Access Compliance Report

Public Rights-of-Way

(Curb Ramps)

Intersection ID: 13395	Main Street: LOVE_AV	Cross Street: N_SHARON_AMITY_RD	Location: SW
ADA ID: 57749116AB22	Ramp Type: Perp	Initial Pass/Fail: Fail	Overall Compliance: No
Codes/Mitigation Info/Possible Solution			Severity Score: 30
			Field Measurements/Component Compliance

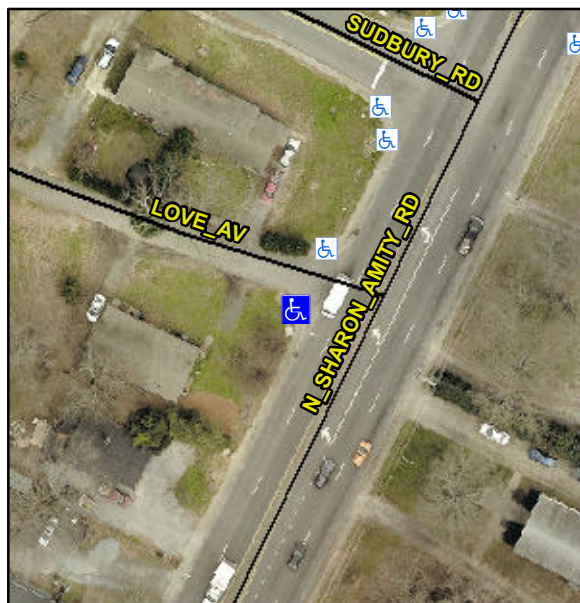
Not Found, R304.5.1, R304.2.2

Compliance	Description	Data	Compliance	Description	Data
N/A	Ramp Length (in)	60.0	No	Ramp Slope (%)	8.9
No	Ramp Width (in)	35.0	Yes	Ramp XSlope (%)	1.0
N/A	Flare Type LT	N/A	N/A	Flare Type RT	N/A
N/A	Flare Slope LT (%)	N/A	N/A	Flare Slope RT (%)	N/A
N/A	Flare Traversable LT?	N/A	N/A	Flare Traversable RT?	N/A
N/A	Landing Length (in)	N/A	N/A	DWS Provided?	N/A
N/A	Landing Width (in)	N/A	N/A	DWS Contrast?	N/A
N/A	Landing Slope (%)	N/A	N/A	DWS Length (in)	N/A
N/A	Landing X Slope (%)	N/A	N/A	DWS Full Width?	N/A
N/A	Landing Curb? (Y/N)	N/A	N/A	DWS Offset (in)	N/A
N/A	Shared Landing?	N/A			
N/A	Gutter Ponding?	N/A	N/A	Gutter Slope (%)	N/A
N/A	Gutter Lip Ht (in)	1.0	N/A	Gutter X Slope (%)	N/A
N/A	Painted X Walk1?	No	N/A	Painted X Walk2?	N/A
	X Walk 1 Direction	To NE		X Walk 2 Direction	N/A
N/A	X Walk 1 Width (in)	N/A	N/A	X Walk 2 Width (in)	N/A
	X Walk 1 Slope (%)	2.6		X Walk 2 Slope (%)	N/A
	X Walk 1 X Slope (%)	1.8		X Walk 2 X Slope (%)	N/A

Remove & Replace Entire Ramp.
